Hi-Fi Products
Service Bulletin

Model: CDP-C9ESD/C10/C15ESD/C90ES/C100/
C900/C910

No. 300

Subject: Discs Jam When Returned To The XA-10B Magazine

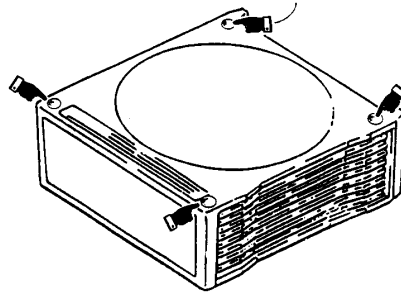
The discs occasionally jam when being returned to the XA-10B magazine.

Improved magazines have a number (1,2,3, or 4) stamped into one of these depressions.

Unimproved magazines do not have numbers stamped into the depressions.

Replace the magazine with an improved version. The improvements were implemented in production starting in August 1991. Improved magazines can be identified as follows:
